Date of Issuance: May 25, 2023	Effective Date: May 29, 2023
Owner: City of Eden	Owner's Contract No.: N/A
Contractor: Darnell Construction	Contractor's Project No.: N/A
Engineer: Enprotec / Hibbs & Todd, Inc.	Engineer's Project No.: 7300
Project: North Water System Improvements	Contract Name: North Water System Improvements

**CHANGE ORDER 3**

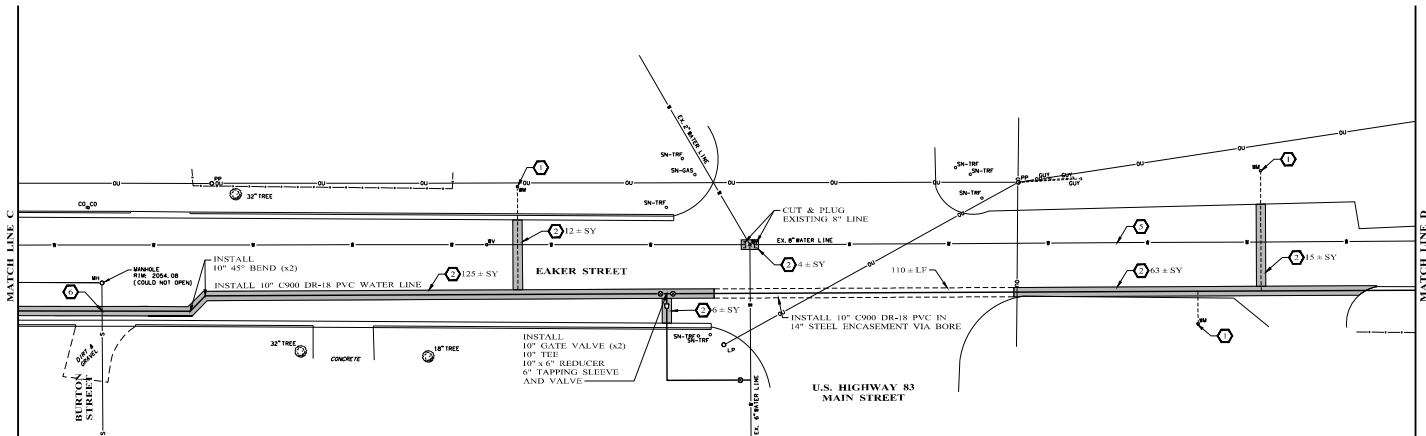
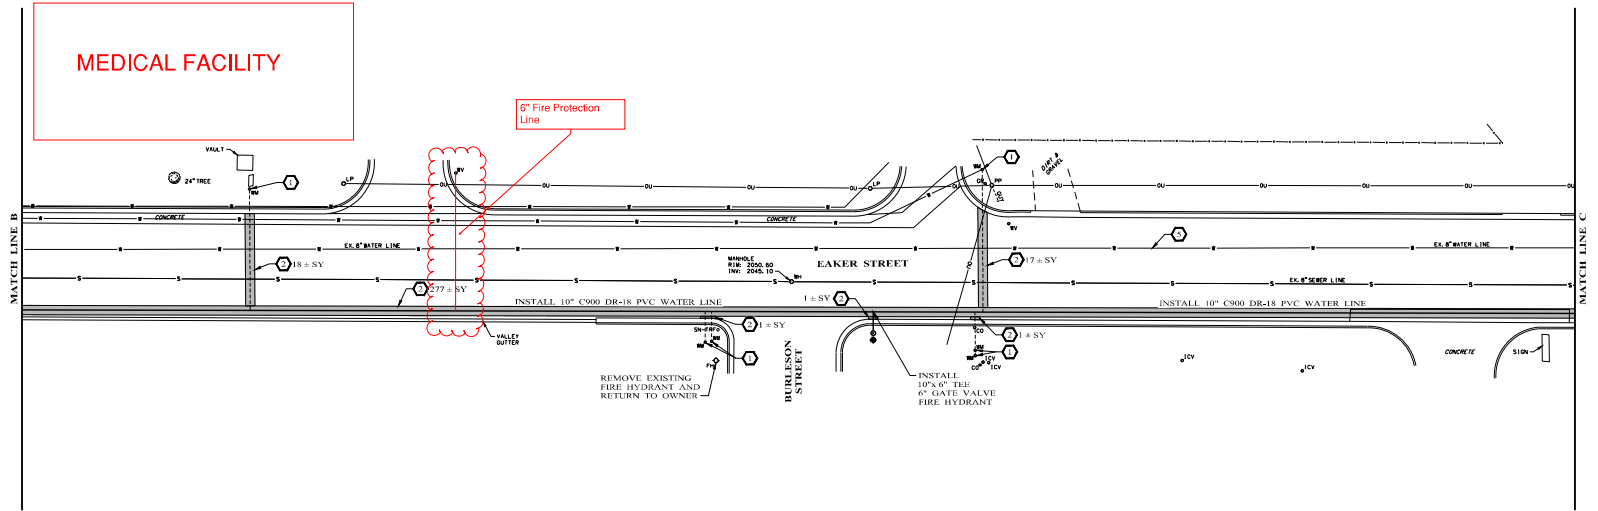
A previously unidentified fire flow line supplying protection to medical/nursing facility on Eaker Street was discovered after abandonment of the existing water main. Additional work was necessary to reconnect the existing fire line to the newly installed main.

- Addition of \$8,772.00 due to field discovered items during construction.

MEDICAL FACILITY

6" Fire Protection Line
